ARCHITECTURAL  
REVIEW COMMITTEE

## TOWN OF BROOKFIELD ARCHITECTURAL REVIEW COMMITTEE STAFF REPORT

RE: ARC Staff Report – May Agenda Items

Strand Associates, Inc.® (Strand) has finished its initial review of the construction drawings and Storm Water & Erosion Control Calculations for the Quest Interiors Development that were received from the Town on April 25, 2023, for conformance with the Town specifications and general engineering practices. Before construction may begin, the contractor shall submit all required permits for the development to the state, Wisconsin Department of Natural Resources (WDNR), Town, and any other relevant agencies. New drawings, stormwater management plan and calculations, and a letter describing the revisions should be returned to Strand after the following concerns have been addressed.

**Sign #3 – Flex Replacement Faces**

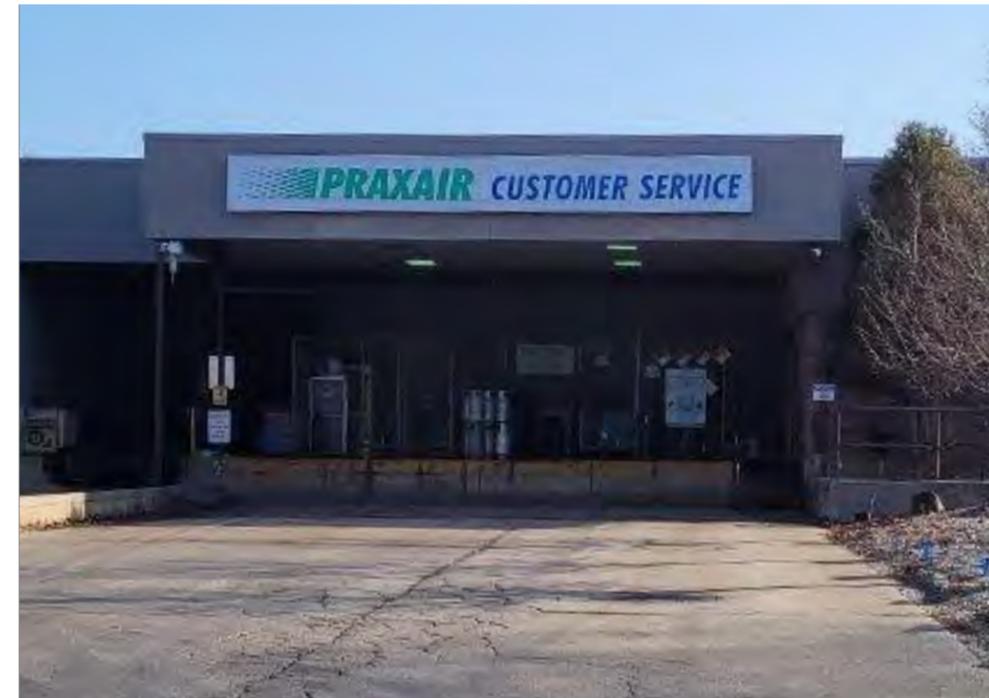
- Total allowable signage area = 174.13 square feet
  - Background color is light and dark blue, white, and consists of white and blue lettering.
  - Illuminated. Approximately half of the sign has a white background. The Committee can choose to approve as presented or required that the background be changed to a different color or opaque.

**CIVIL SITE PLAN**

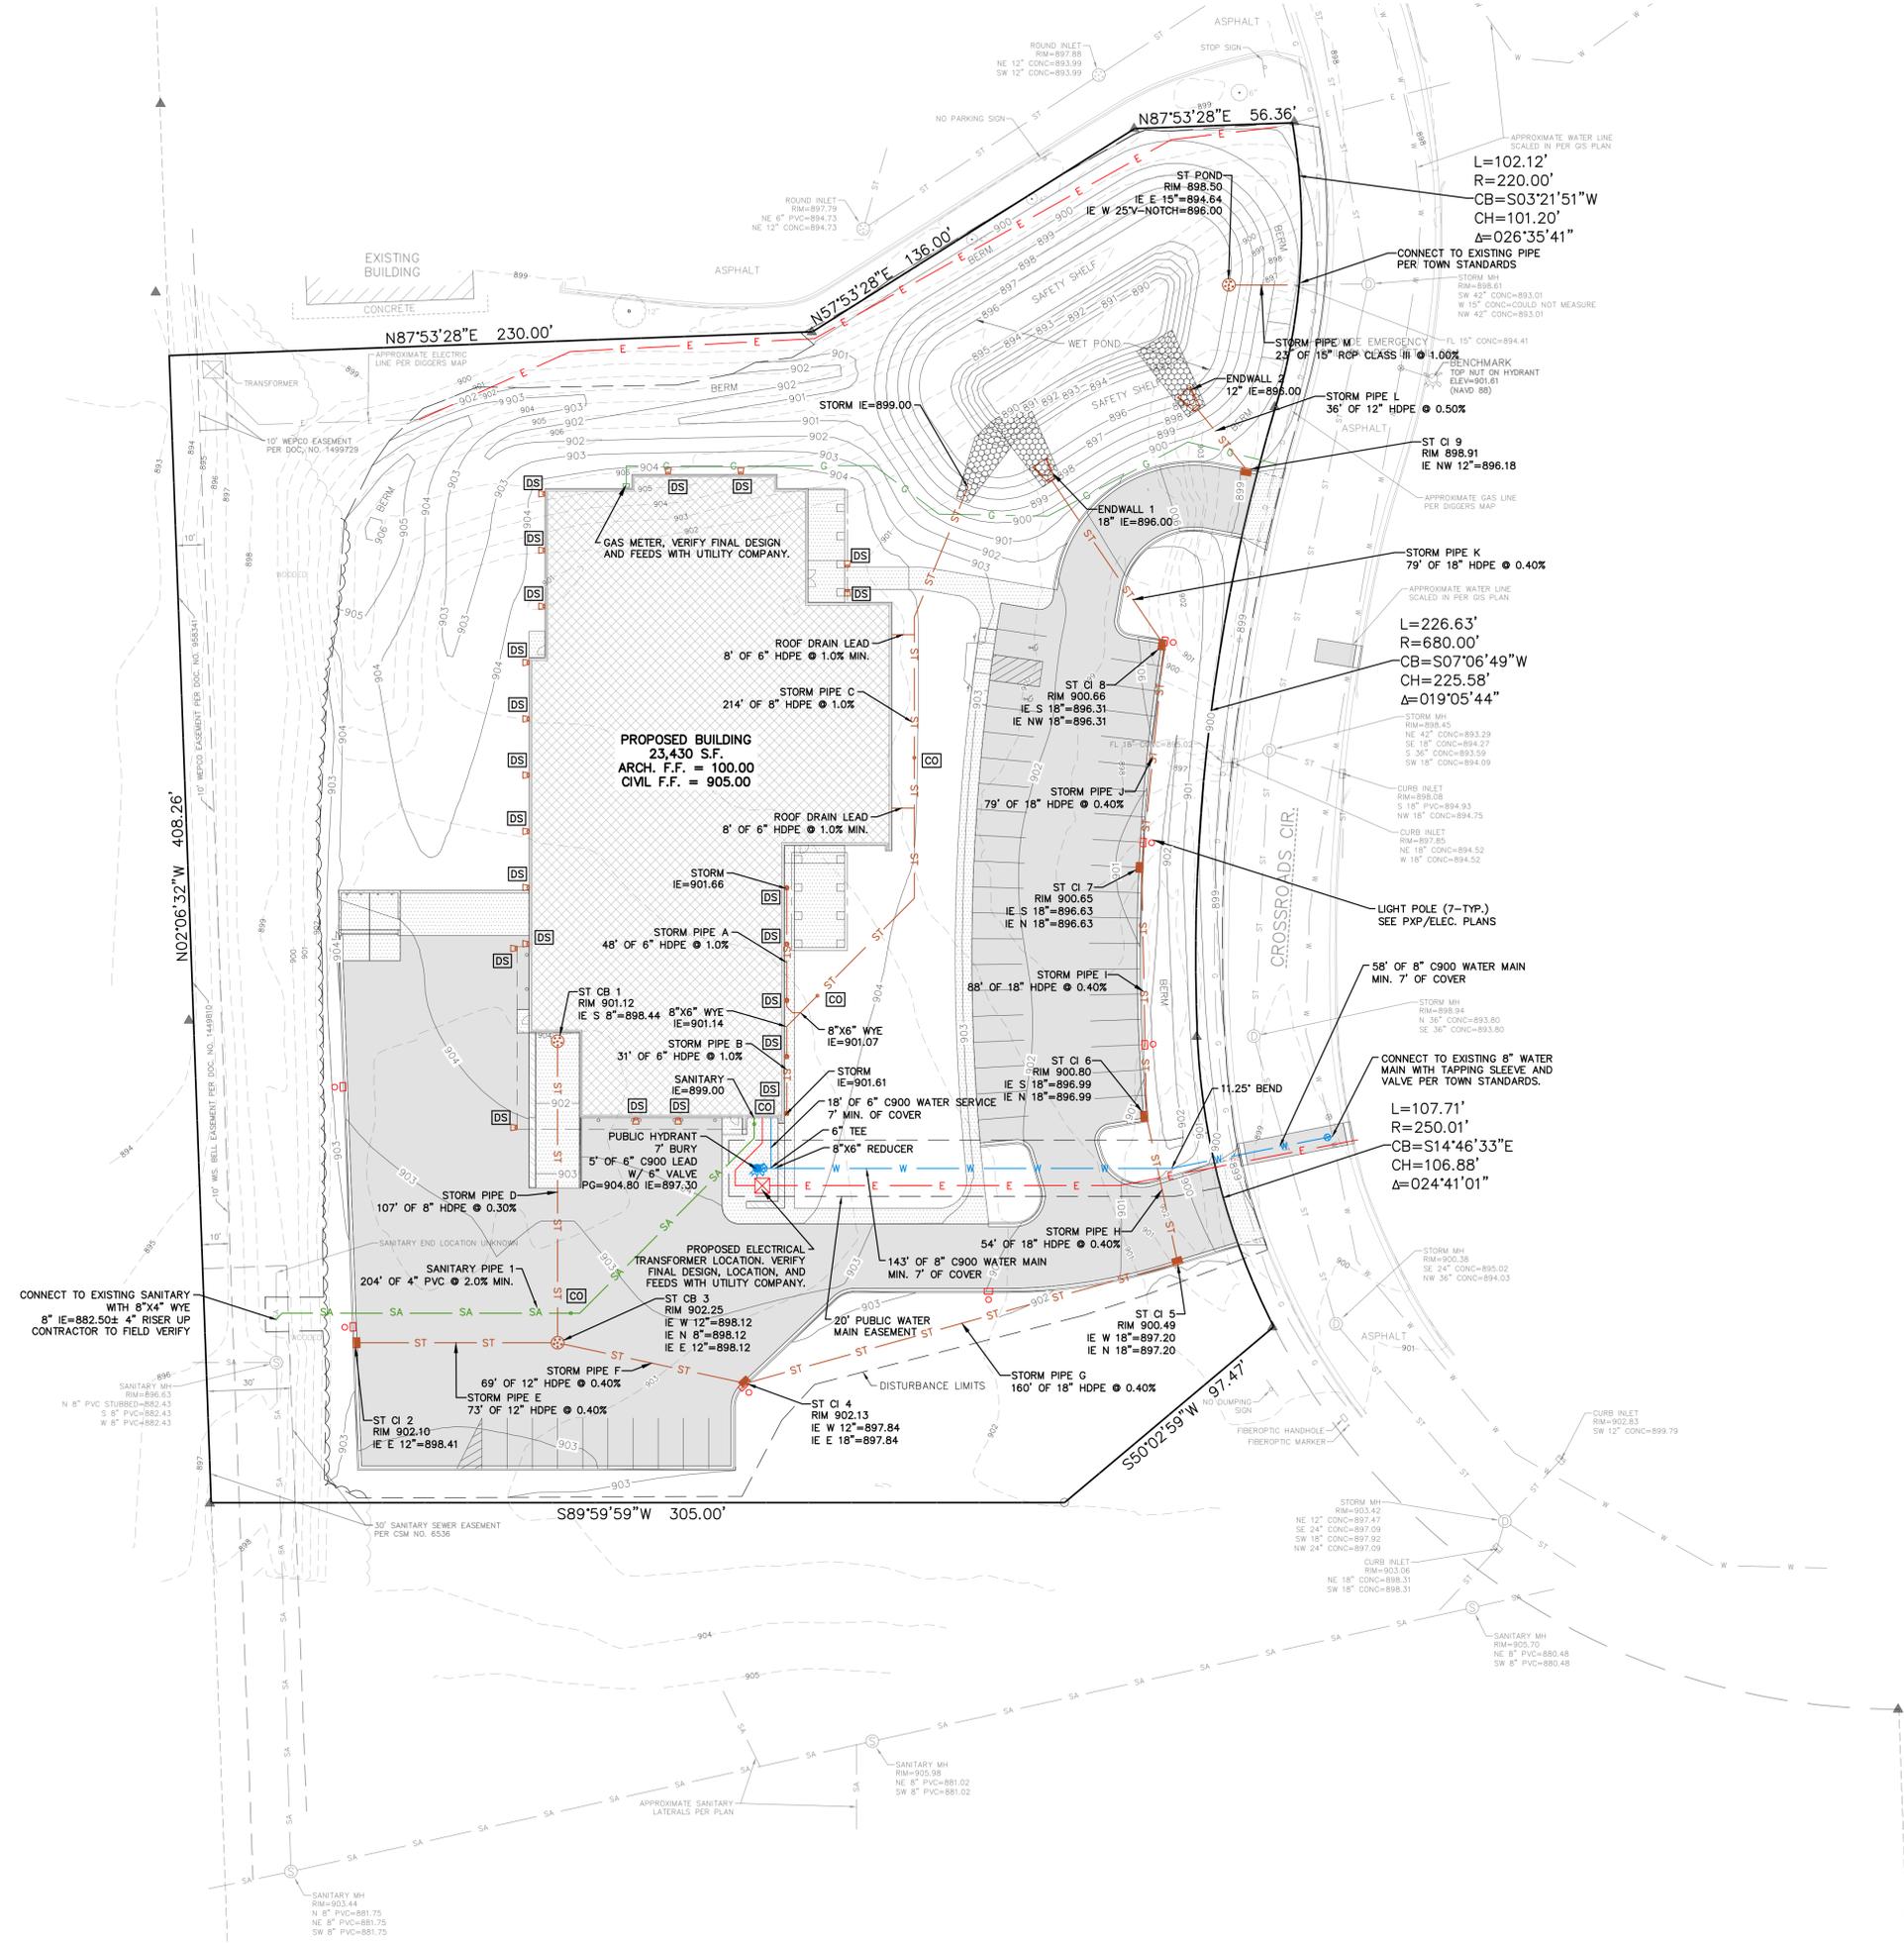
1. According to 17.06(3)(c)(4) in the Town ordinance, the minimum dimensions for all parking spaces provided for use by physically disabled shall be 12 feet by 18 feet. It appears that these stalls are 9 feet by 18 feet.
2. There is a callout for a Keynote 27 in the plan, but there is no description for “27” in the Keynote legend.
3. A turning movement exhibit should be provided to verify the largest vehicle (including any emergency vehicles) that will access the site can perform the required turning movements with the proposed layout.

TREE PLANTING DETAIL  
NO SCALE

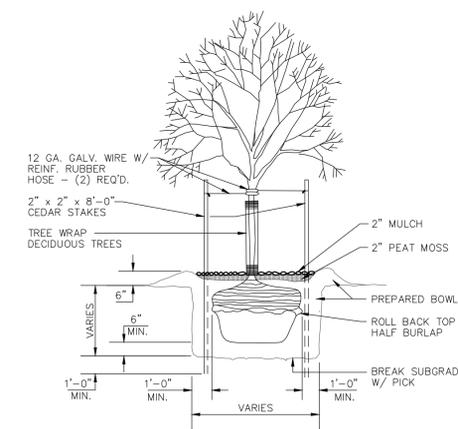
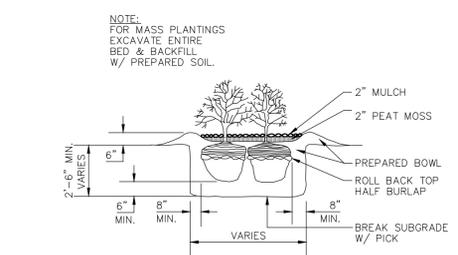
5. To potentially avoid installation “settling” of plantings, burial of root collars, and potential survivability issues; please consider additions to the Tree Planting and Shrub Planting Details. This may involve altering the figure or potentially calling out plants to be “set” in the planting hole on a rigid substrate and similarly denoting the location of the root collar relative to planting and mulch placement.

**C1.4**

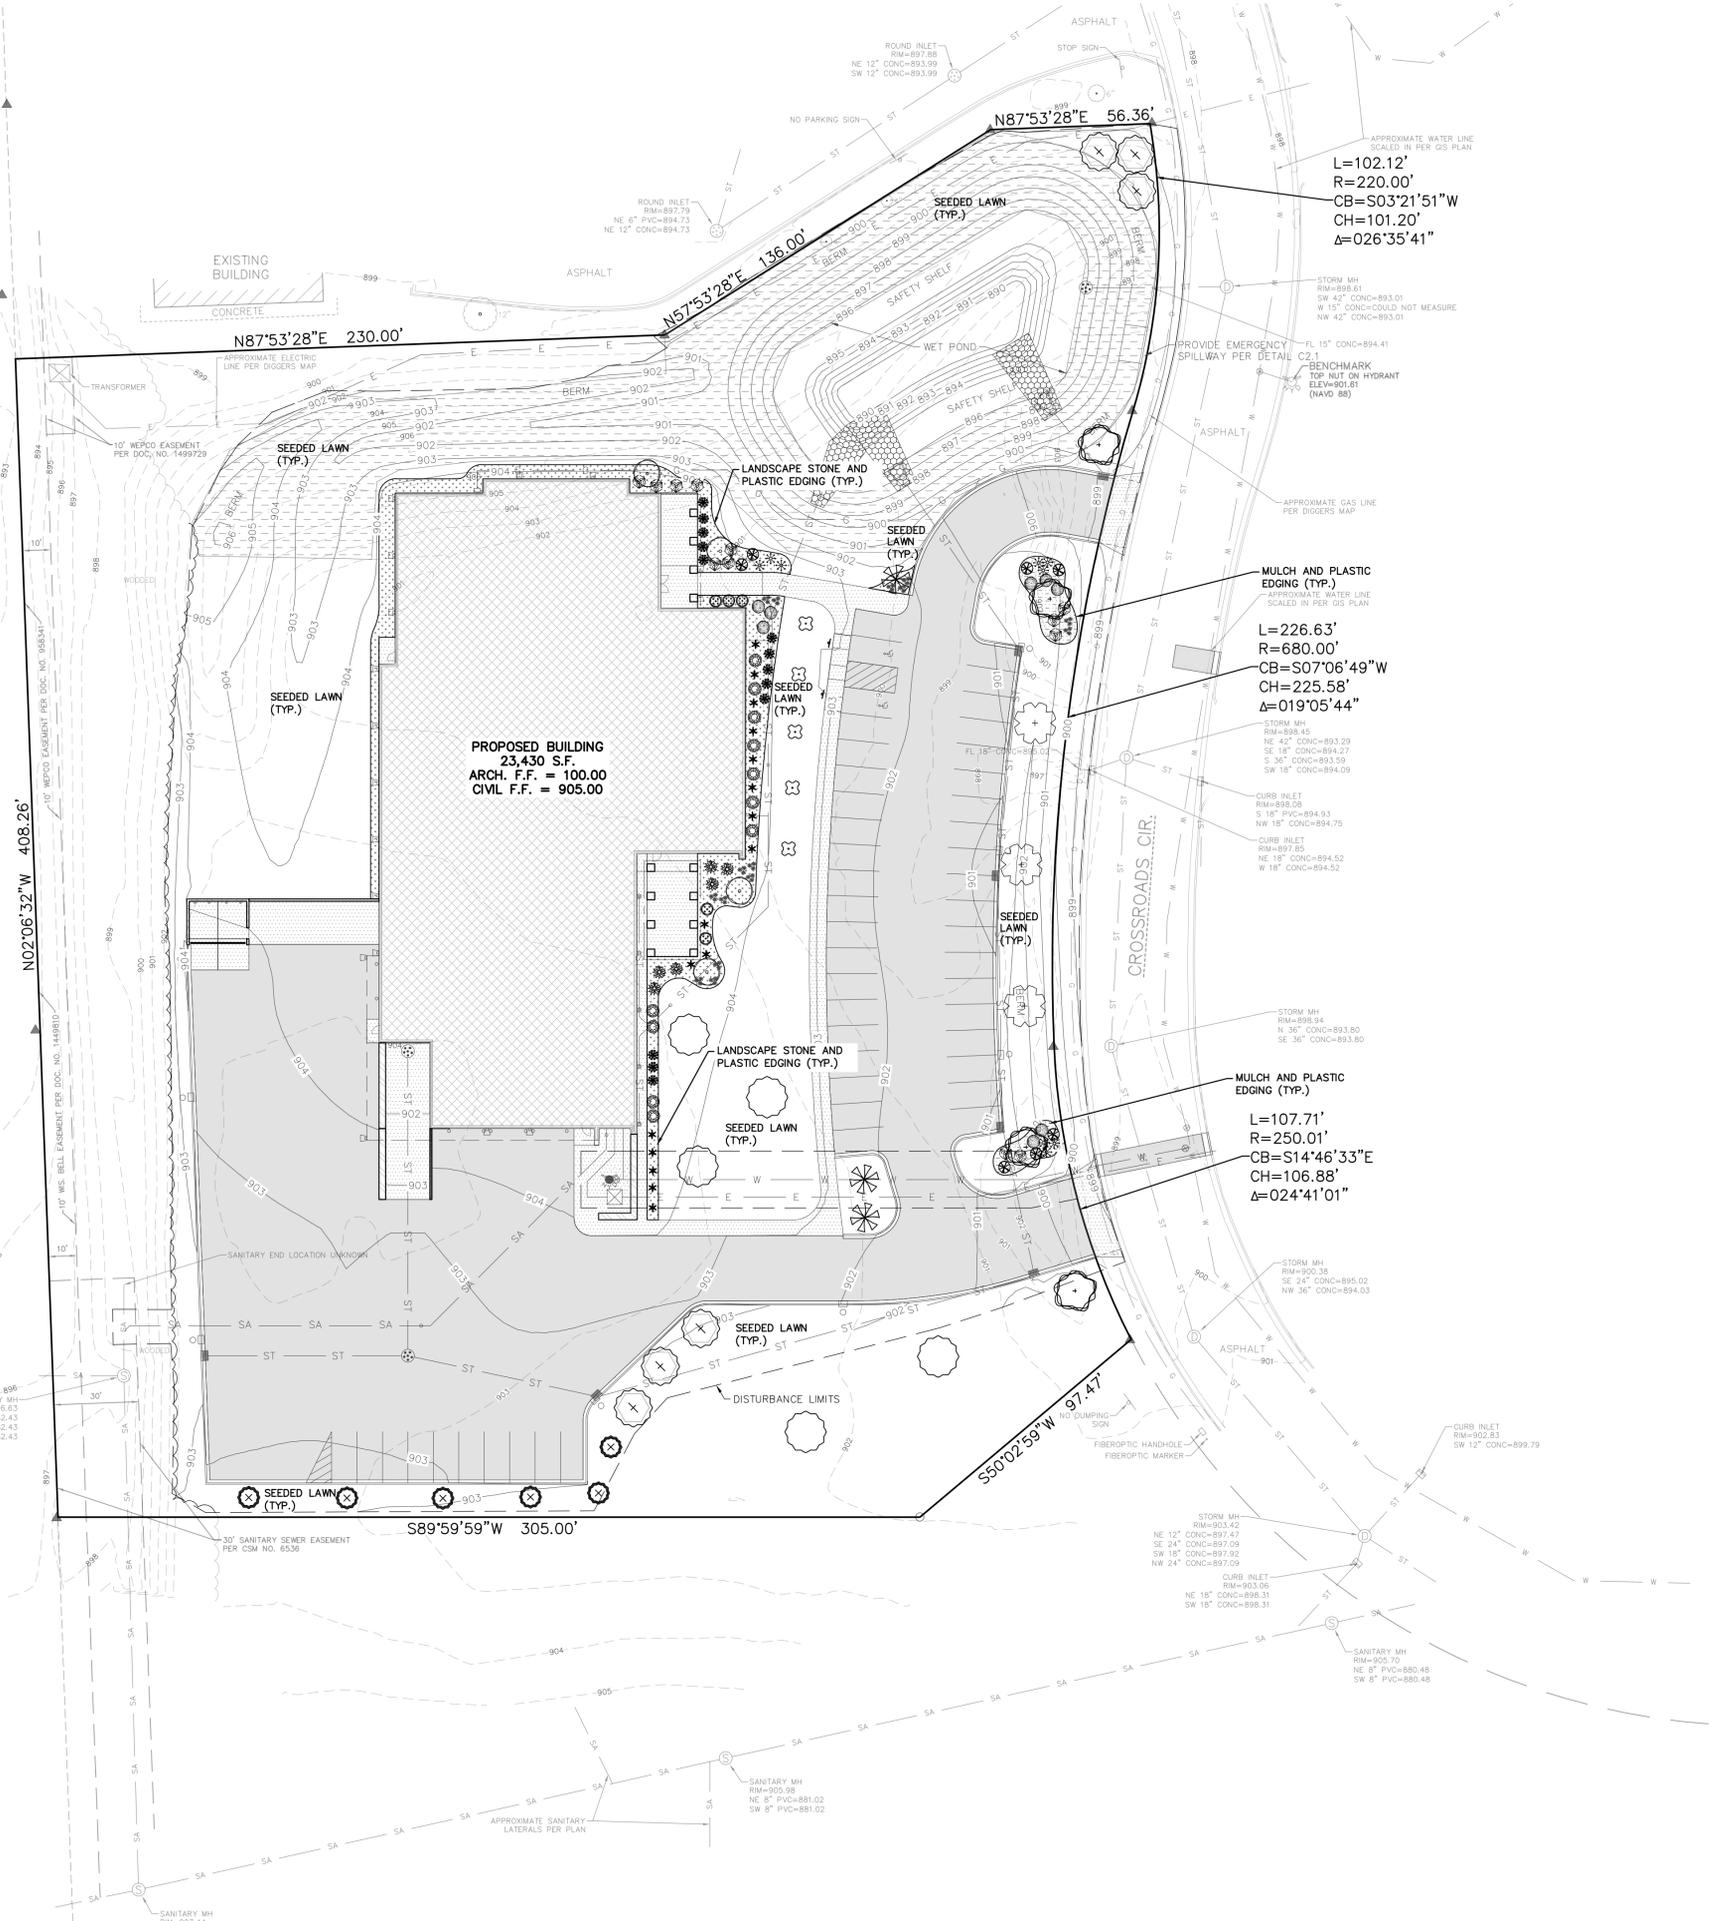
1. Please denote intended tree protection or woodland area protection provided on-site.
2. Landscaping Planting Schedule Comments
  - a. According to plant symbols and the plant data chart, selected species appear appropriate. A full comparison of plan quantities as laid-out versus in the planting table was not completed. It may be appropriate for plant callout leaders for use in the field or for final reviews. Planting densities, arrangement, and selection appear appropriate. See notes.

- c. Deciduous shrub “Planted Size” below 18 inches does not meet code. Please remove 15-inch reference for deciduous shrubs.
  - d. Similarly, arborvitae “Planted Size” should be corrected to the 6-foot requirement, in accordance with code.

- e. Please revise Botanical Name (genus) for Karl Forester Reed Grass as “*Calamogrostis*.”
3. Long-term light pole interference–The seeded lawn area between the parking lot and Crossroads Circle (and some other project areas) contain light poles with large deciduous tree plantings (basswood and honeylocust) within 10 to 12 feet of the poles. Please evaluate spacing arrangements or evaluate the use of smaller trees as needed.

4. Because of proximities within 12 feet of the Crossroads Circle road surface, please review planting beds that are present north and south of site access drives to confirm that they are appropriately resistant or distant to potential salt spray and other effects of the roadway and associated ditch.

**WET RETENTION POND**  
NO SCALE

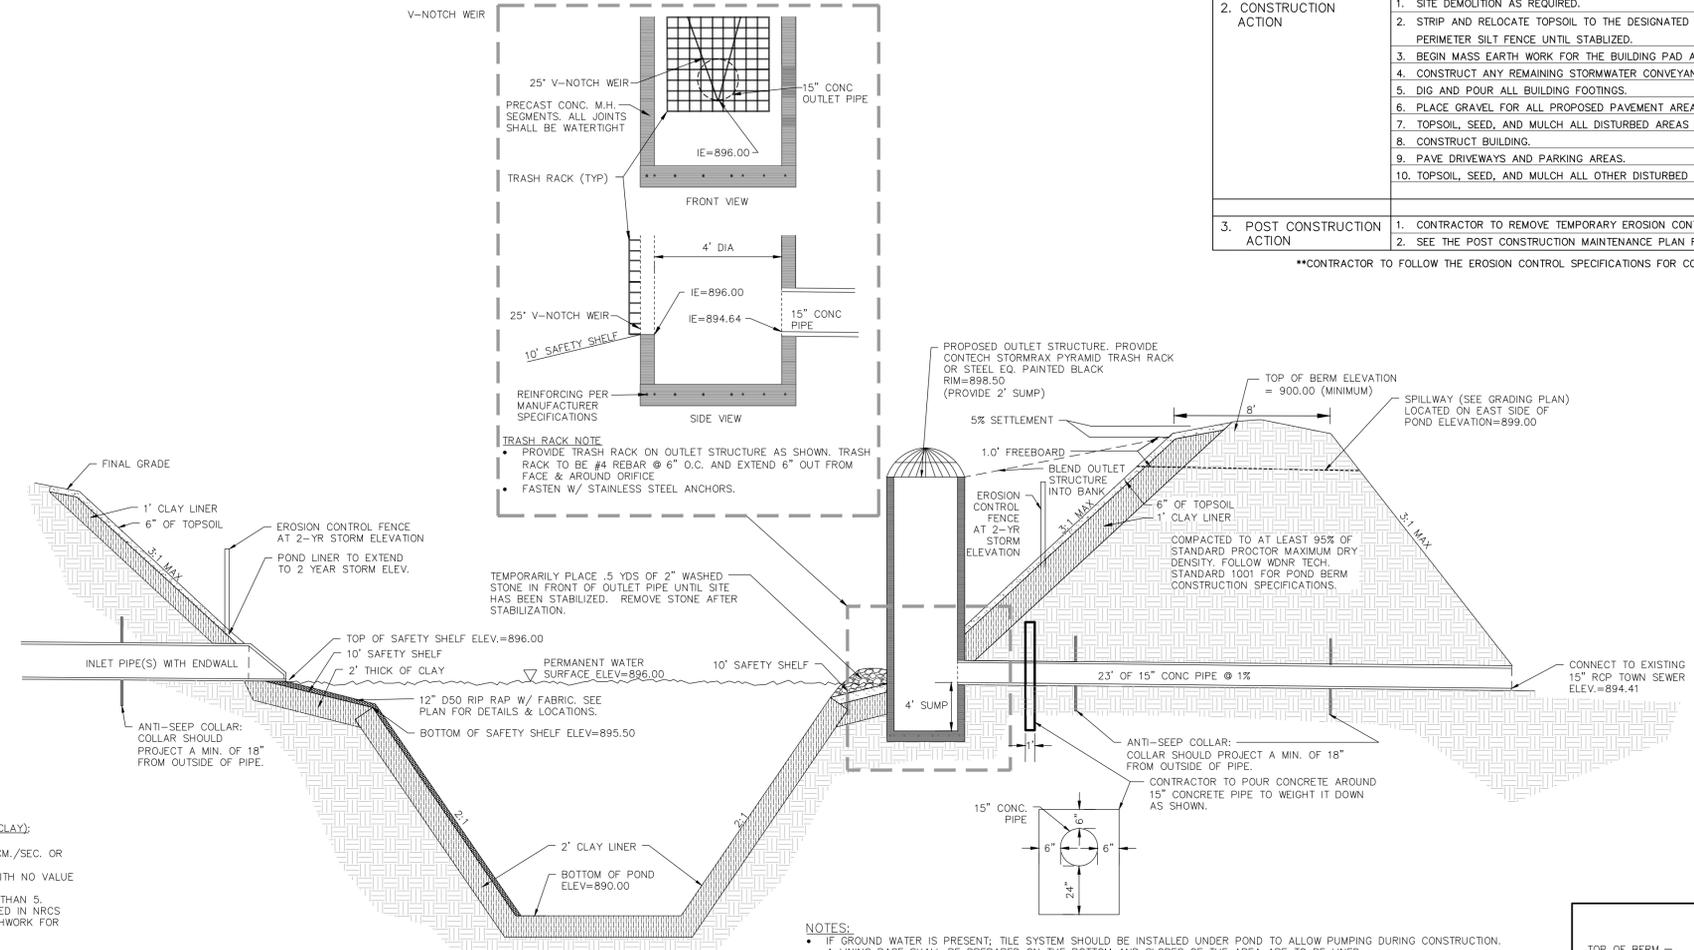
1. The Wet Retention Pond Detail should include the 2.5-foot rise dimension for the sharp-crested vee weir that is modeled in HydroCAD.
2. The Wet Retention Pond detail notes a 2-foot sump in the callout for the pyramid trash rack on top of the outlet structure which does not match the callout for a 4-foot sump dimension noted on the bottom of the structure. Detail should be updated accordingly.
3. The Wet Retention Pond Detail contains callouts for the “2 Year Storm Elev.”. This elevation should be provided on the detail so the contractor knows the exact elevation to install the erosion control fence and pond clay liner.
